TO: Mayor Andre Dickens, City of Atlanta
ATTN TO: Monique Forte, Assistant Director, Office of Design, Planning Studio
FROM: Mike Alexander, COO, Atlanta Regional Commission
RE: Development of Regional Impact (DRI) Review

Name of Proposal: 1060 Donald Lee Hollowell DRI 4187

1060 DONALD LEE HOLLOWELL DRI
City of Atlanta
Natural Resources Department Review Comments
July 15, 2024

DRI SITE PLAN

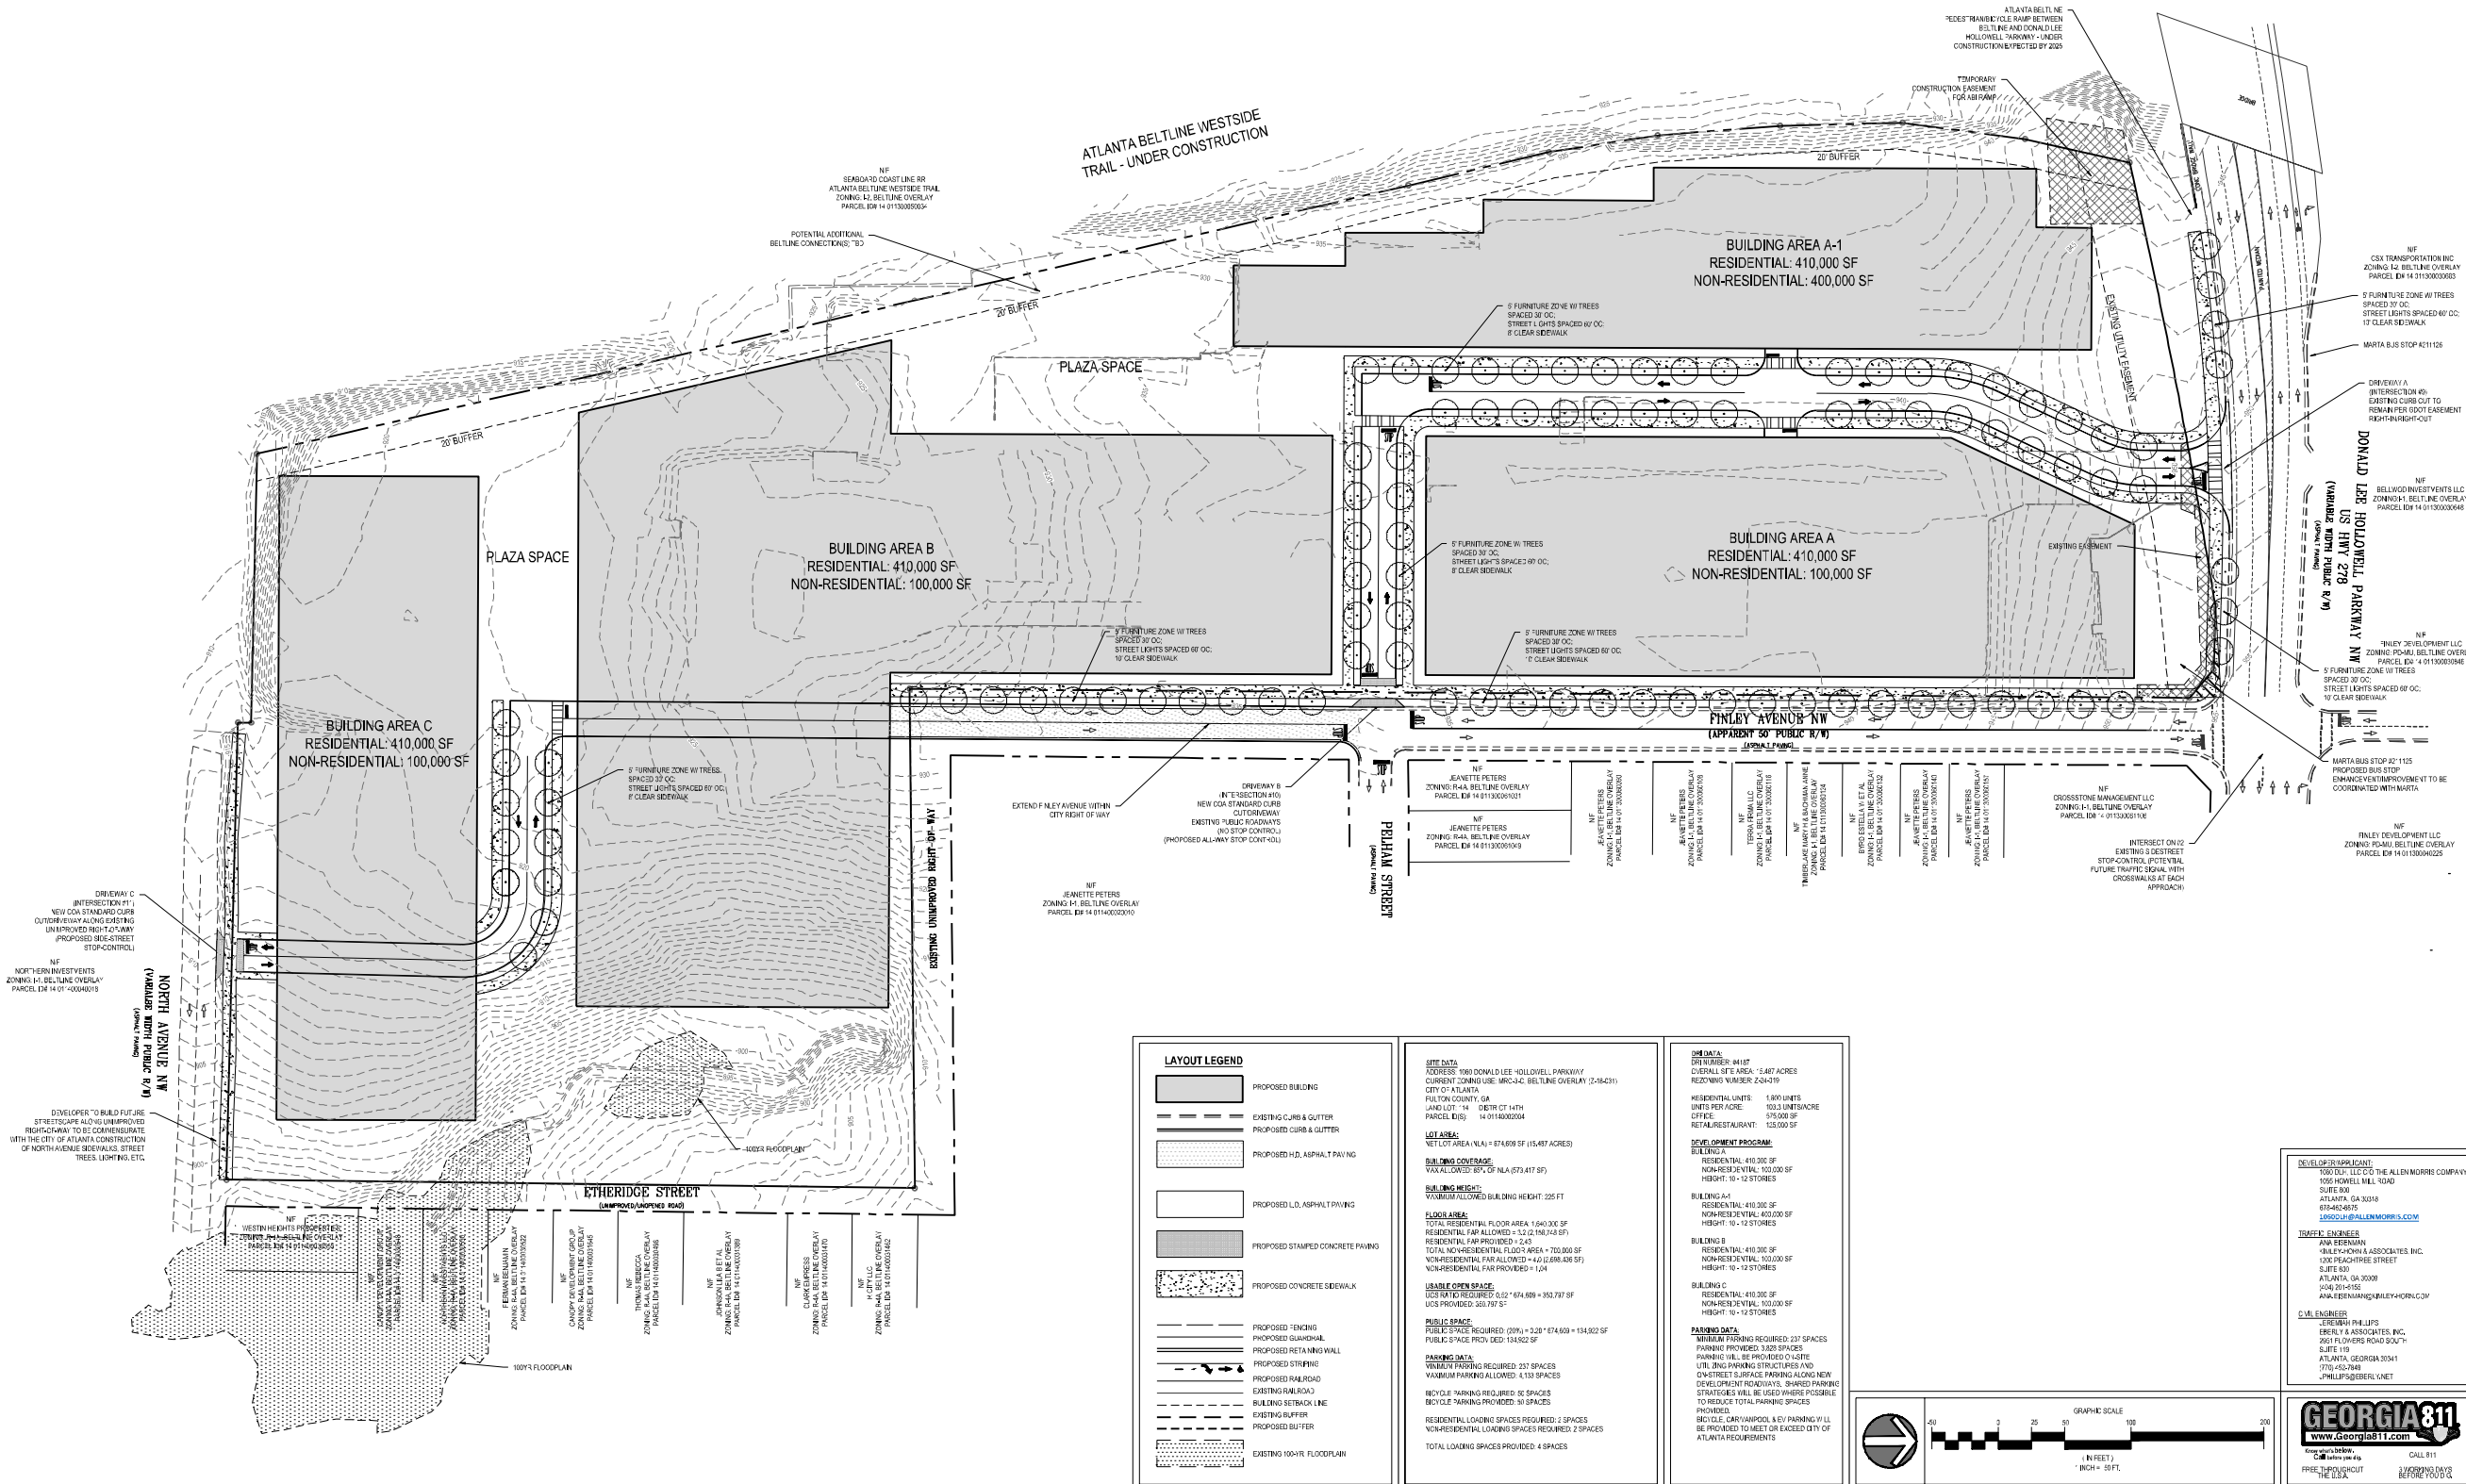
The project could be better aligned with regional environmental and heat mitigation policies by preserving more of the densely wooded area at the SE corner of the site.

Provision of a traffic signal and crosswalks at Finley Avenue and Donald Lee Hollowell Parkway would best integrate the project with available transit and pedestrian connections.

Final design of the right-in, right-out driveway on Donald Lee Hollowell Parkway will need to be carefully coordinated with the City of Atlanta to ensure that inherent vehicular and pedestrian conflicts are minimized.

A significant portion of the existing site is heavily wooded; utilization of a sensitive site design, land clearing and construction approach in order to preserve as many trees as possible would be supportive of regional heat mitigation and stormwater management policies.

Provision of a traffic signal and crosswalks at Finley Avenue and Donald Lee Hollowell Parkway would best integrate the project with available transit and pedestrian connections.

Final design of the proposed right-in, right-out driveway on Donald Lee Hollowell Parkway will need to be carefully coordinated with the City of Atlanta to ensure that inherent vehicular and pedestrian conflicts are minimized at this sensitive location where a Beltline access ramp meets the sidewalk. At a minimum, the driveway should include a raised crosswalk design that offers a safe and welcoming pedestrian route as well as signage noting the vehicles must yield to pedestrians.

Attached comments received from MARTA include: (1) add direct pedestrian access to Donald Lee Hollowell Pkwy from Building Area A to ensure convenient access to bus stop; (2) coordinate street trees near bus stop with MARTA in order to ensure bus stop is not blocked and waiting passengers have proper visibility; (3) the planned Bankhead Station Transit-Oriented-Development is within a 5-minute walk of the project and the plans should be reviewed and integrated into the subject development wherever possible.
